COMMITTEE OF THE WHOLE (PUBLIC MEETING) – MARCH 2, 2021

COMMUNICATIONS

Re: Letter of Concern
2232394 Ontario Inc. - Notice of Meeting
OP.20.010 & Z.20.31

Figure 1 – also refer to attachment 1

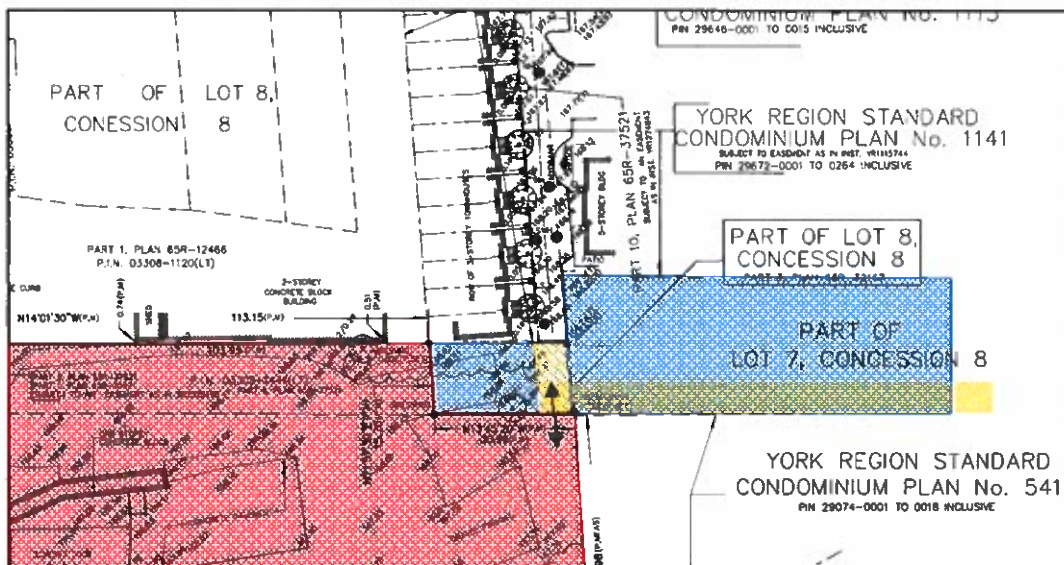
It is our opinion that the 2232 property should incorporate a future access/easement at the north-west corner of the 2232 property to ensure the potential to achieve a connecting access with the Canuck property should the Canuck property redevelop. Such consideration would ensure that future redevelopment of Canuck's property would be a continuation of the proposed and existing development immediately adjacent, ensuring an integrated neighbourhood and more efficient flow/movement of traffic. Figure 1 below, illustrates Canuck's property (red) immediately adjacent to the 2232 property (blue) with potential right-of-way/easement configuration (yellow) and access connection point highlighted (green arrows). The protection of this access for the potential future redevelopment of Canuck's property would result in only minor adjustments to the proposed development on the 2232 property and not result in a loss of units. Specifically, the minor adjustment of the right-of-way layout from a curve to a t-shaped intersection only results in the reduction of the driveway dimensions of the semi-detached units.

Figure 7: Concept Plan (Architectural Drawings, p. 12) superimposed on Schedule 2 of Secondary Plan green space location

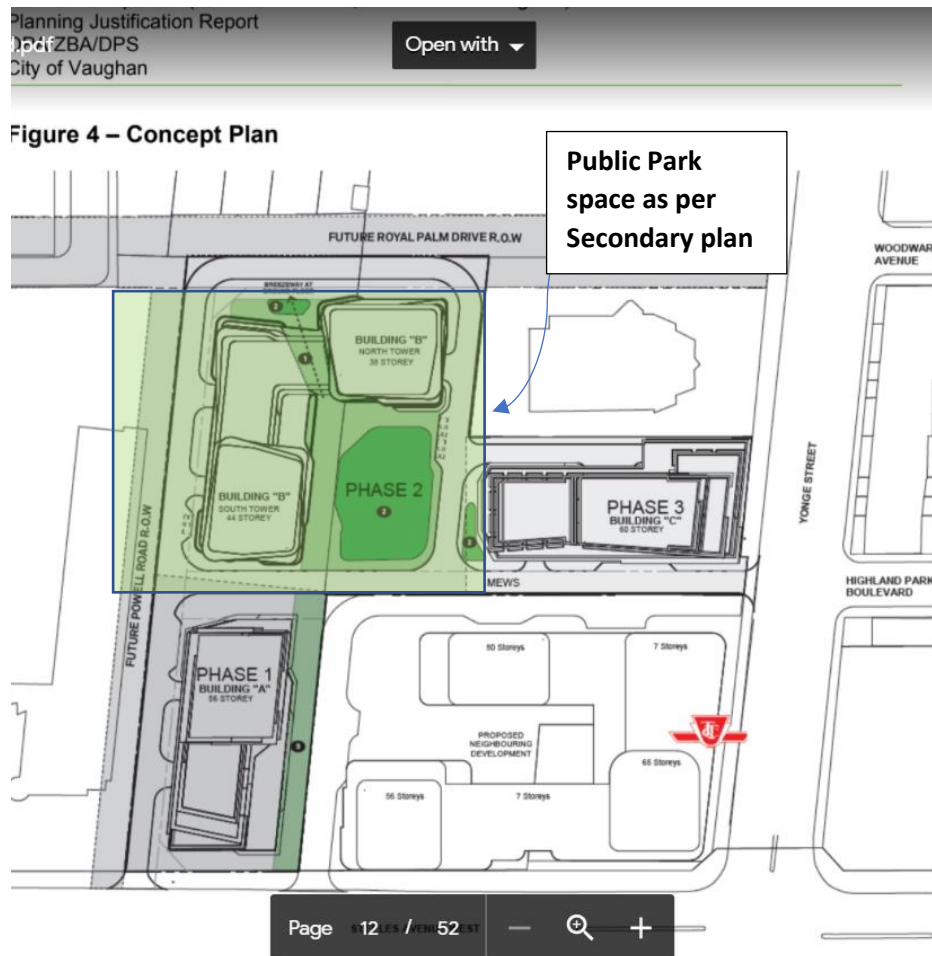
So it would appear that the developer generally supports the Yonge Steeles Corridor Secondary Plan. However, most significantly, as Figures 5, 6 and 7 illustrate, the developer has actually proposed to build two buildings on three-quarters of the largest designated green space in the entire Secondary Plan. **This is an unconscionable appropriation of critically necessary, designated “land to be conveyed to the City for Park Purposes” (ie. Park)** as a “Private-owned Publicly accessible Space” (POPS), which will only be built during Phase 2 (Building B, with the 38 and 44 storey tower on top of a 12-storey podium. So there will be zero provided green space at grade for the occupants of the first buildings. And no public park. This is appropriation of public space for private use, which must be vigorously challenged.

Figure 8: Site Setbacks – Building B North Tower (Source: Architectural Drawings, p. 7)

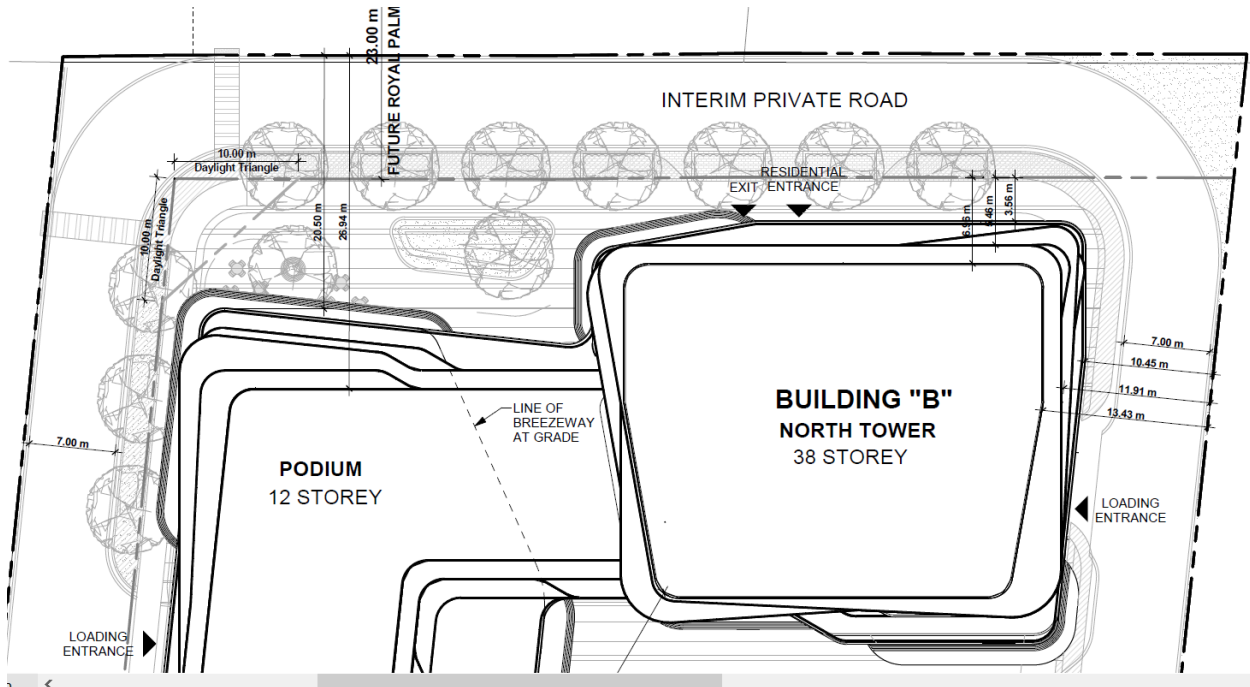
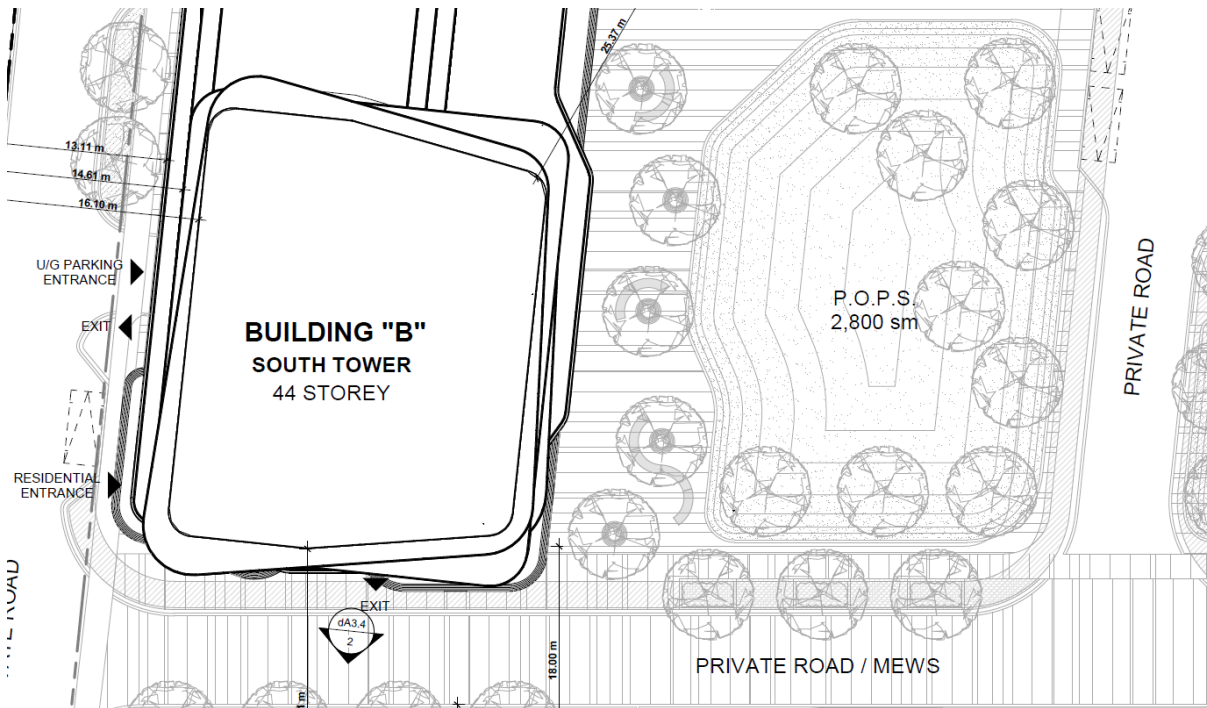
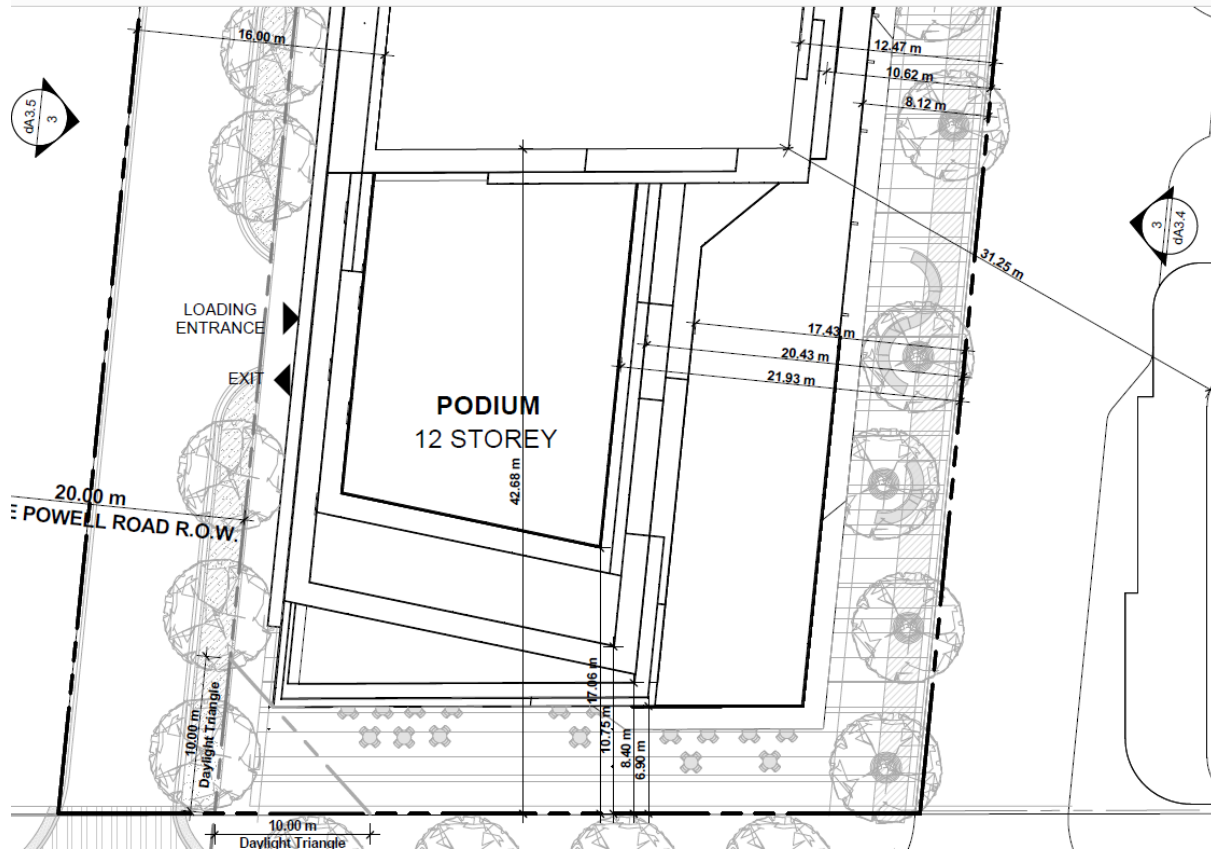
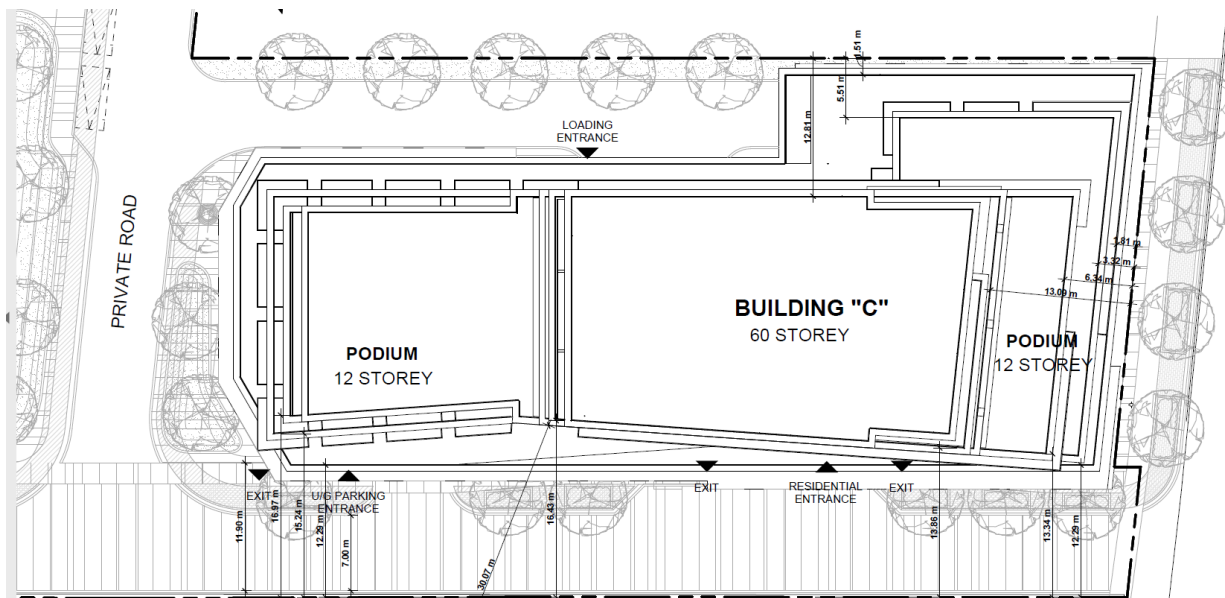
As illustrated by Figures 8, 9, 10, and 11, the site appears to have a 7m setback for the private interim road, and small setbacks between the road and the building perimeter. (The Zoning by-law requires a 7.5m setback for an RA3 apartment zone, and half of the height where a building exceeds 11m in height).

Figure 12 Privately-owned publicly accessible spaces (source: Architectural Drawings set, p.7)

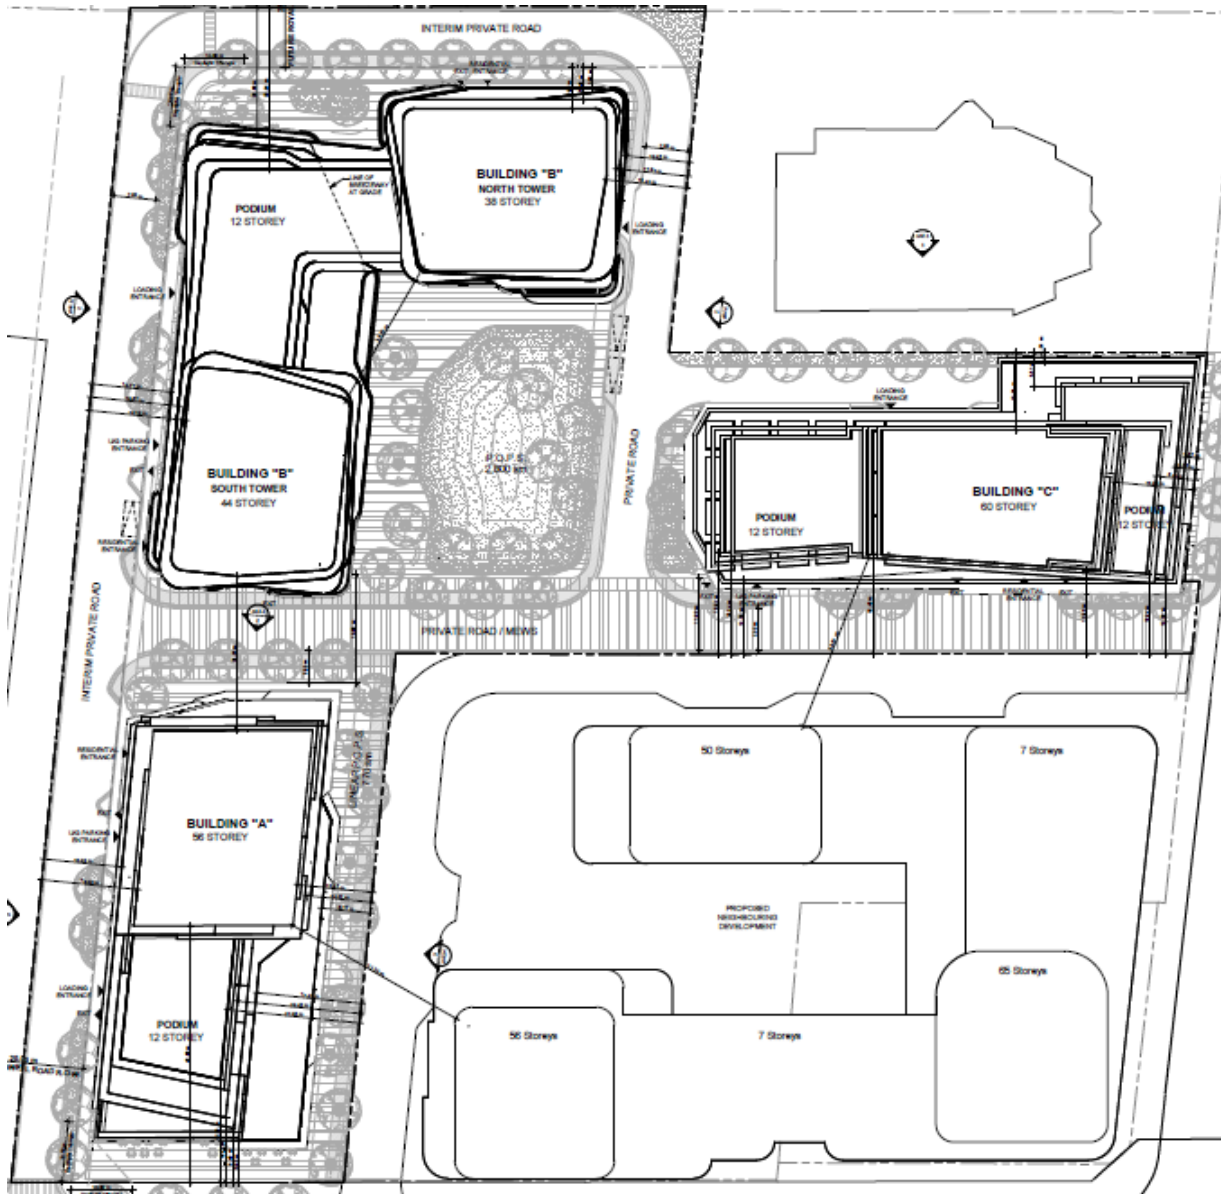
Figure 12 illustrates that there is 3,570m² private accessible open space (POPs), however 78% of that is taken up by the central private green space. Setbacks from roads are all less than the 7.5m required by the Zoning By-Law for an RA3 High Rise Apartment Zone.

Figure 15: Western boundary setbacks (source: Architectural drawings, p. 29)

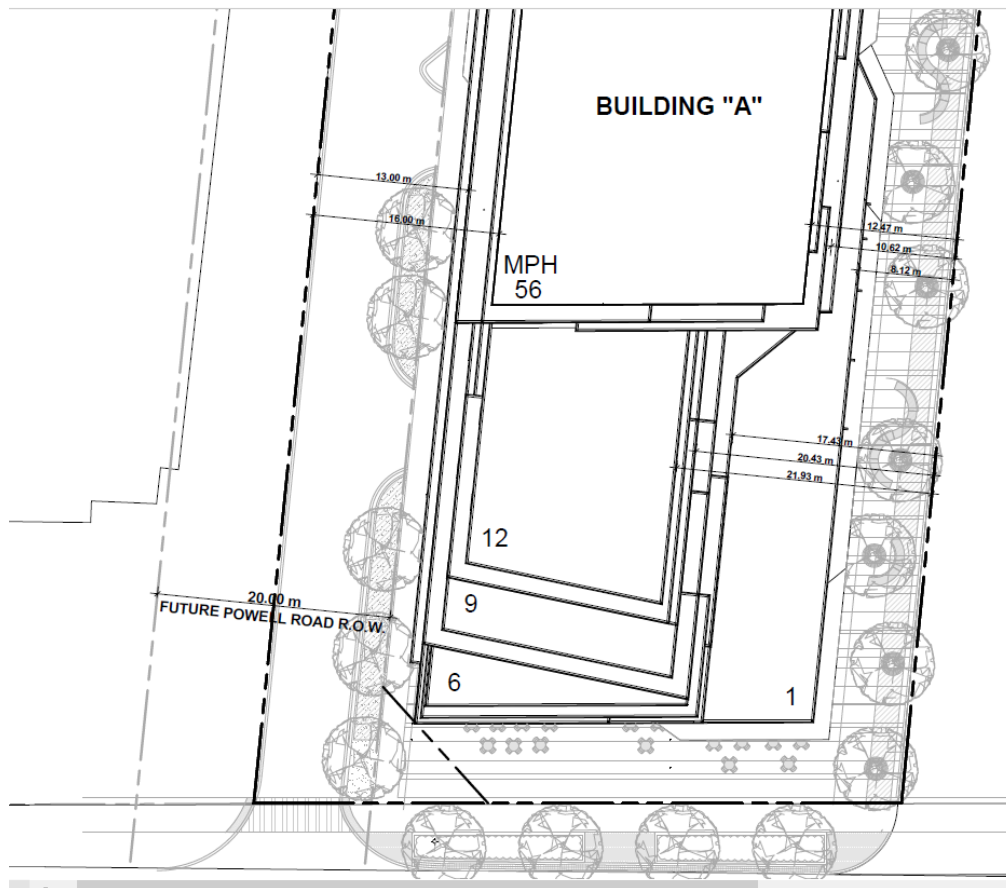
We note, as shown in Figure 15 that the 20m ROW demarcation for Powell (which should be 23m) actually intrudes onto the Sisley Honda property, and since Sisley is not included in this proposal, they cannot be expected to demolish the eastern wall of their building for the ROW. So it is only appropriate that the ROW be entirely within the Humboldt property, which would push the ROW eastward by at least 3 metres for the required ROW, plus another 1 or 2 metres to allow for sidewalk and setbacks to the building edge.

Figure 16: Composite illustration of overlap between 7080 Yonge and 72 Steeles Ave W sites

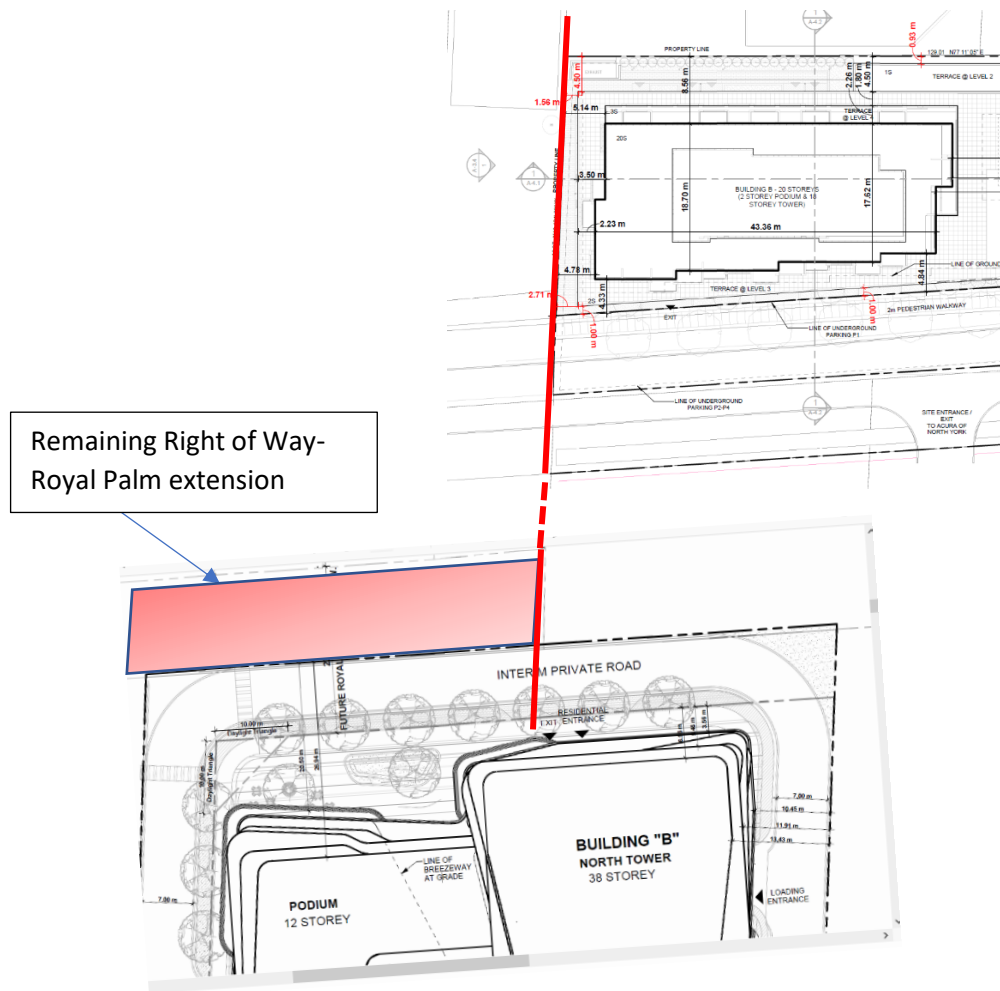
With respect to the Royal Palm extension, as shown in Figure 16, there is a discrepancy between this proposal and the one from 7080 Yonge Street, which is northeast of this site. For 7080 Yonge Street, the developer, Chestnut Hill, has proposed to both convey and construct the portion of Royal Palm, in its full width Right of Way (23m wide) from Yonge Street to the western edge of its property. As illustrated in Figure 16, the western end of 7080 Yonge Street meets the mid-block of the Humboldt site (shown by the red line). Yet, Humboldt does not intend to construct the full width Right of Way from that point to the western end of its property, but to only build a private, interim road of 10m width. Thus, the Royal Palm extension would be 23m wide from Yonge Street to the western end of 7080 Yonge, and then abruptly shrink to only 10m width from that point westward, where it would join up with the private interim Powell road. This is a clear example of the lack of integration and co-ordination of the Humboldt project with adjacent projects. Simply put, we believe that Humboldt must at least convey the full 23m width Right of Way for Royal Palm from the western boundary of the 7080 Yonge Street site to the western end of the Humboldt site. The remaining section is shown in a red shaded box in Figure 16.

Figure 18: Angular plane renderings from the northwest, source: Architectural Drawings, p. 35)

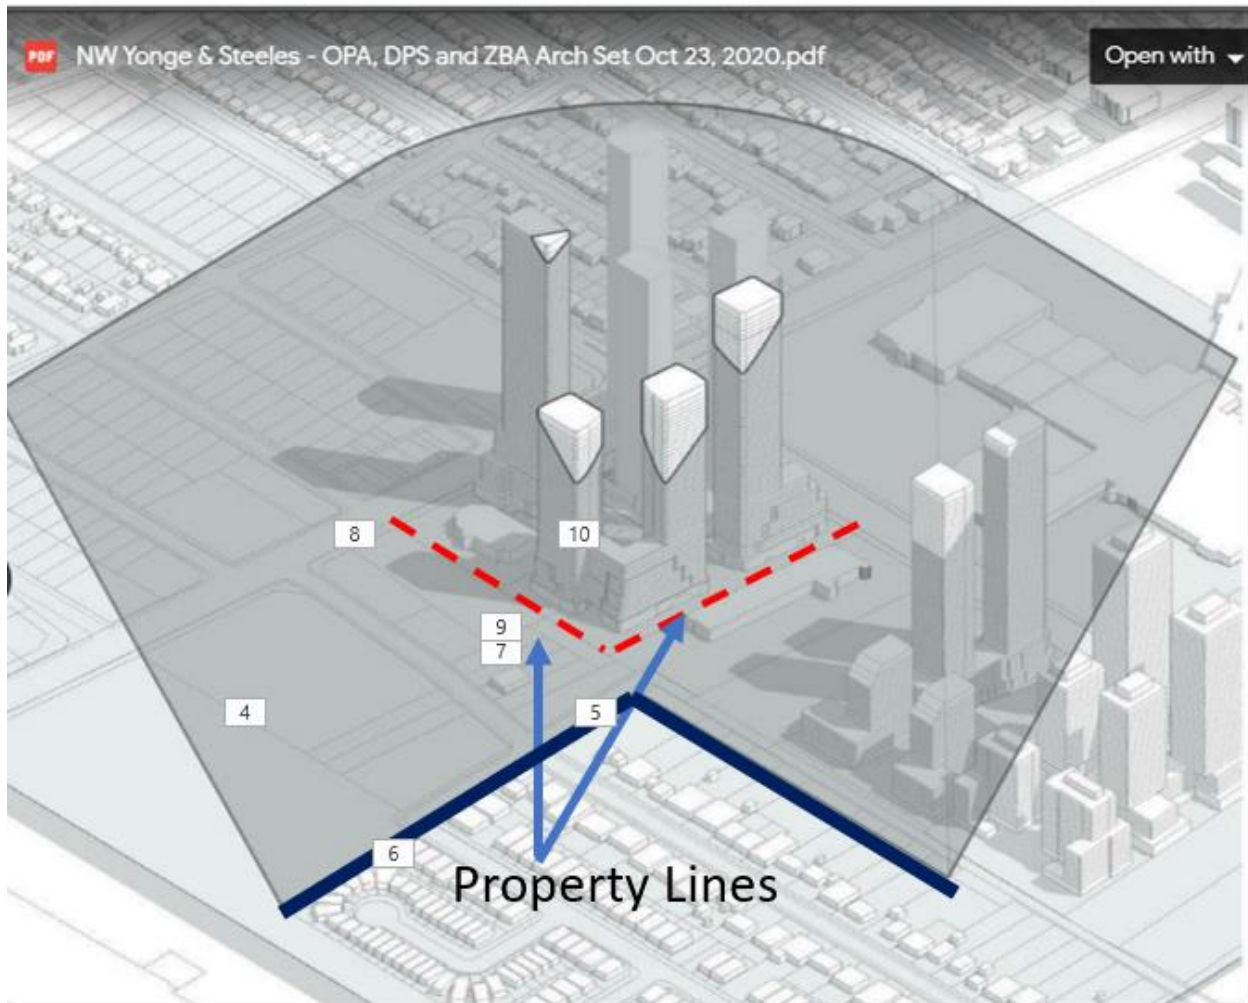
The architect has supplied a 3D schematic shown on page 35, (Figure 18) but the only point of origin appears to be the northwest corner of the site (shown in heavy dark blue lines), taken from the opposite side of the Powell Road extension, and not on the rear property line (the eastern edge of Powell Road) (marked in dashed red lines). The architectural drawings do not illustrate the 45-degree angular plane originating from the rear property line required in the City's Design Review Guidelines (see Figure 17) to transition to the residential neighbourhood to the west. We also note that the architect has chosen to exclude the 7080 Yonge Street rendering on the northeastern side of the property.
